**CITY OF WEST DES MOINES
STAFF REPORT COMMUNICATION**

ITEM: Woodland Estates Plat 1, NE corner of S. Kingswood Court and Stagecoach Drive – Approve a Preliminary Plat to create 22 lots for Single Family Residential development, one outlot for future development and one street lot – Silo 9 LLC – PP-005161-2021

Resolution: Approval of Preliminary Plat

TYPICAL SECTION - 61' B-B PCC ROADWAY - STAGECOACH DRIVE
NOT TO SCALE

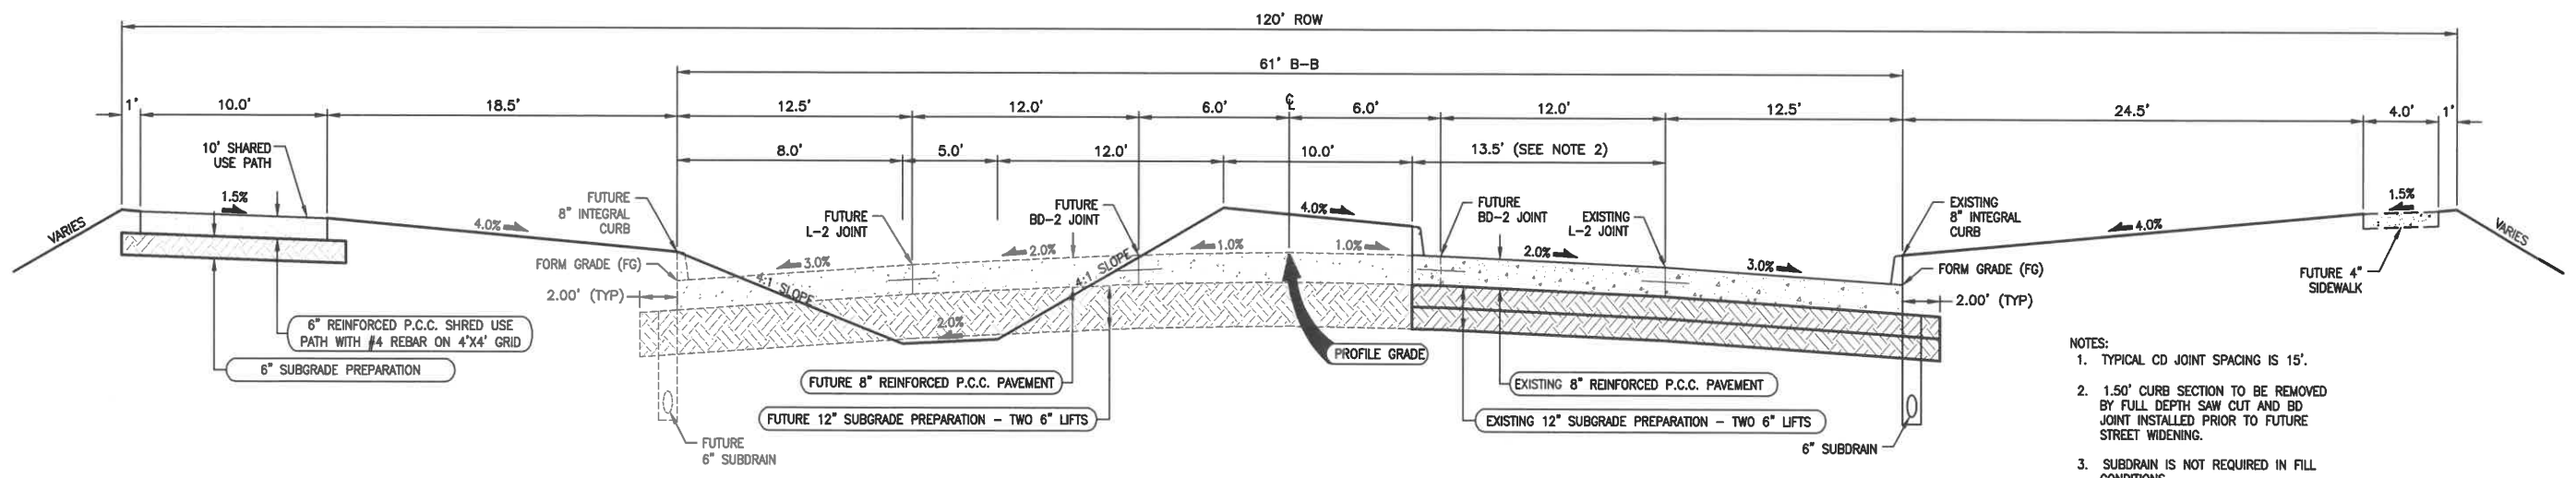
- Stagecoach Trail: A typical ten foot (10') Public Trail is planned for along the north side of Stagecoach Drive but will not be installed until such time that the grading for the widening of Stagecoach Drive is complete. The developer is only responsible for four feet (4'), the typical sidewalk width. A 60/40 Trail Agreement will be executed in conjunction with the Final Plat.

6. The City Council deferring the installation of the ten foot (10') trail along the north side of Stagecoach Drive until such time that Stagecoach Drive is widened or the trail is necessary to make a connection to trails along Stagecoach Drive immediately to the east and west.

WOODLAND ESTATES PLAT 1
LANDSCAPE PLAN

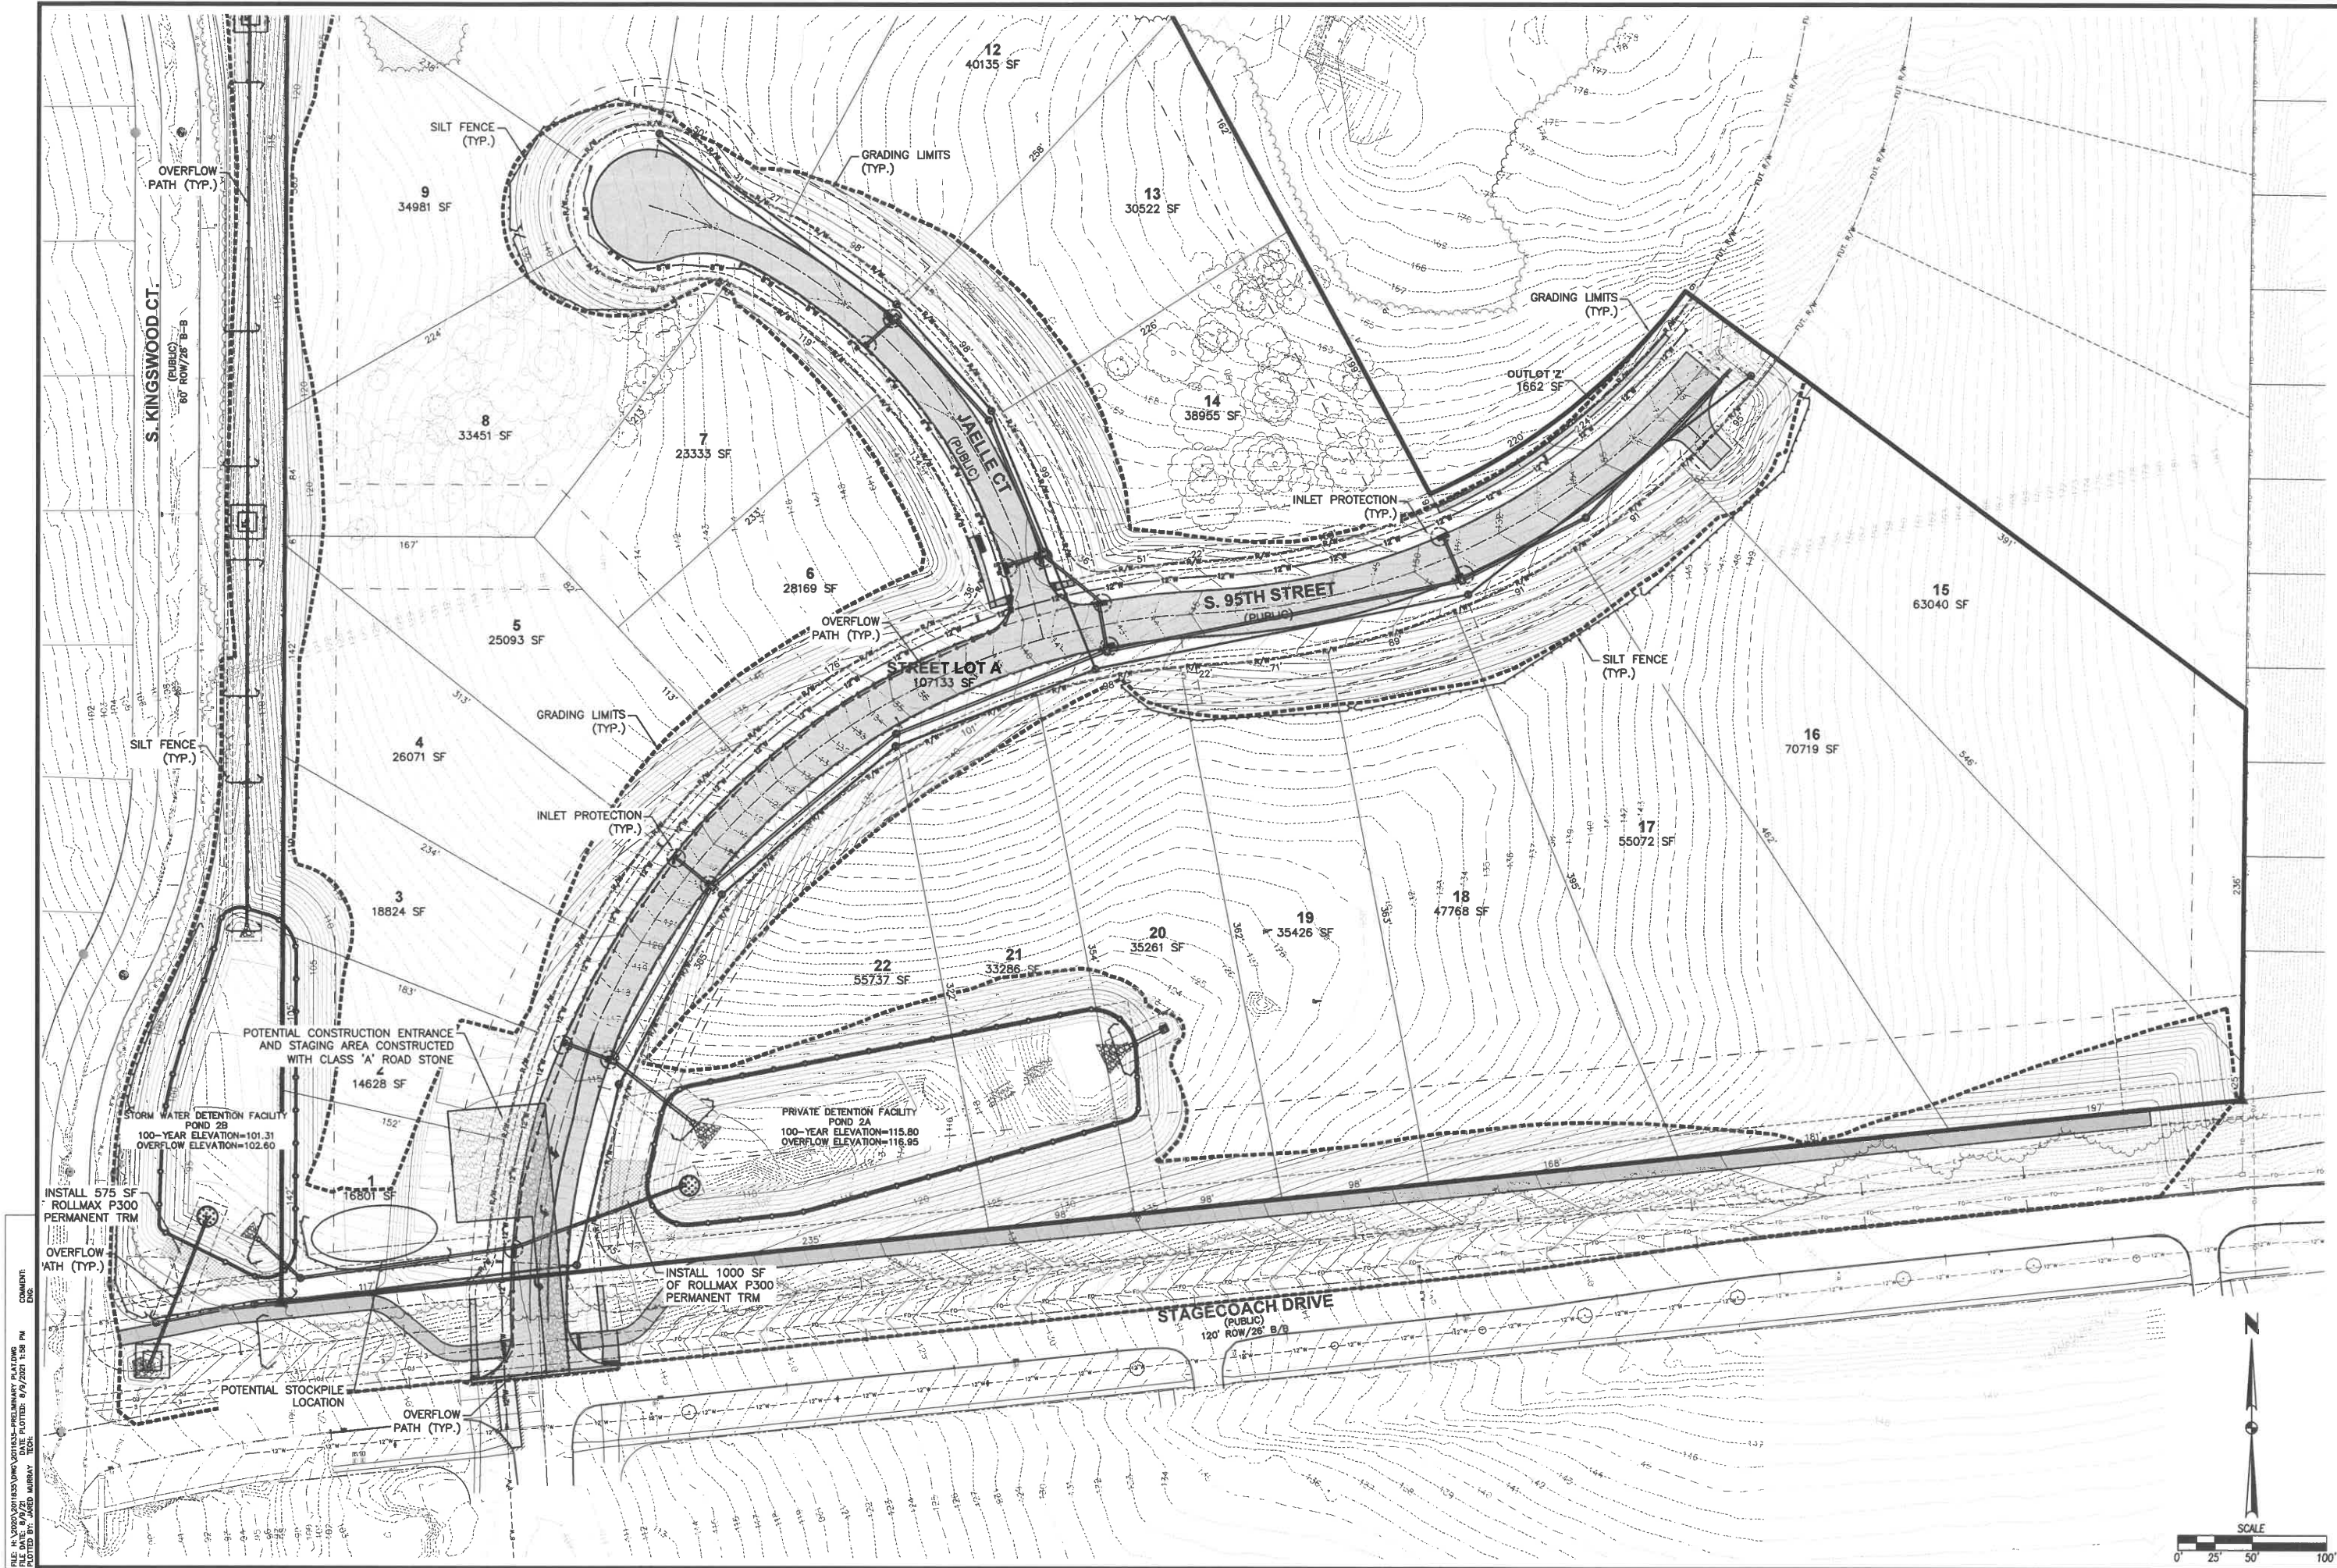
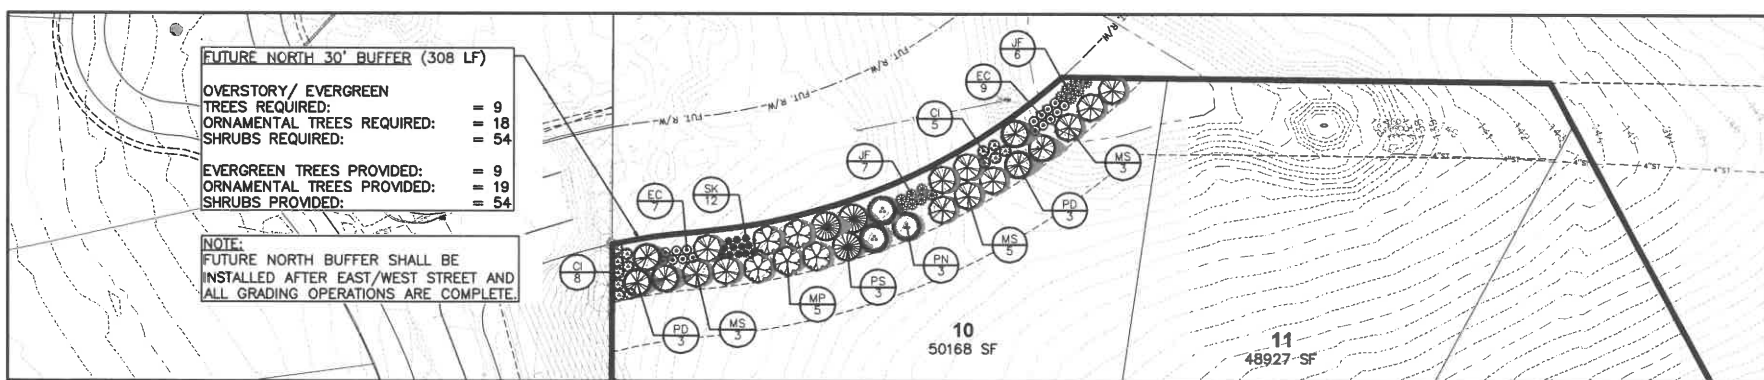
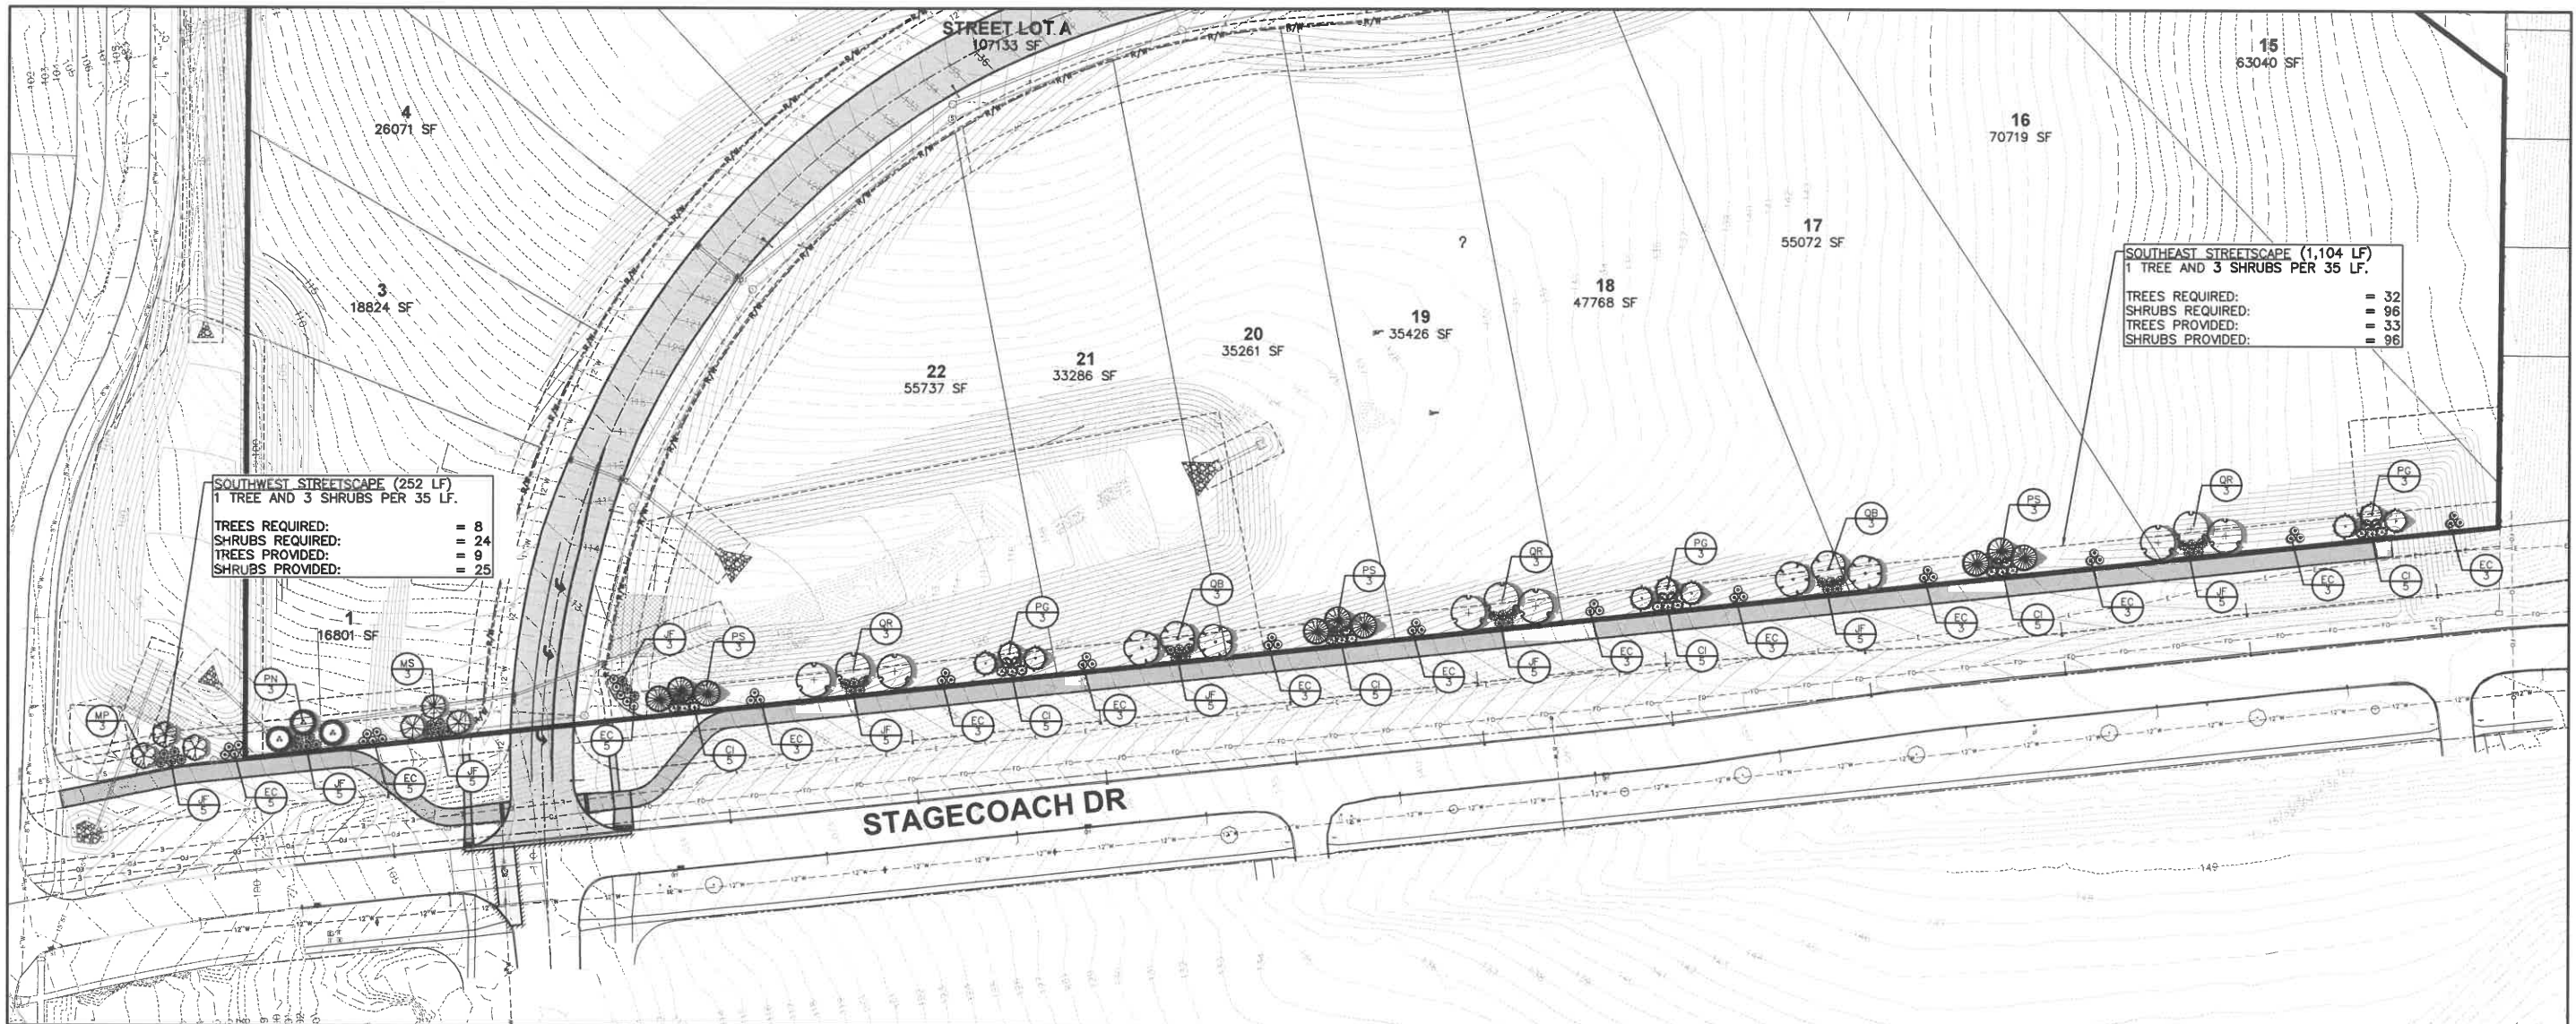
- Lot 10 Buffer: A future roadway extension out of the adjoining Majestic Oaks Subdivision is intended that would border the rear lot line of Lot 10 thus making it a double frontage lot. A minimum thirty-foot (30') landscape buffer is required; however, so as to not disturb the buffer plantings, installation of the buffer is deferred until such time that the roadway extension is constructed.

5. The City Council granting a deferral of the installation of the buffer along the rear lot line of Lot 10 until such time that the adjacent future street is graded and any construction that may affect the survivability of the buffer plantings is complete.

NOTE:
 FUTURE NORTH BUFFER SHALL BE INSTALLED AFTER EAST/WEST STREET AND ALL GRADING OPERATIONS ARE COMPLETE.
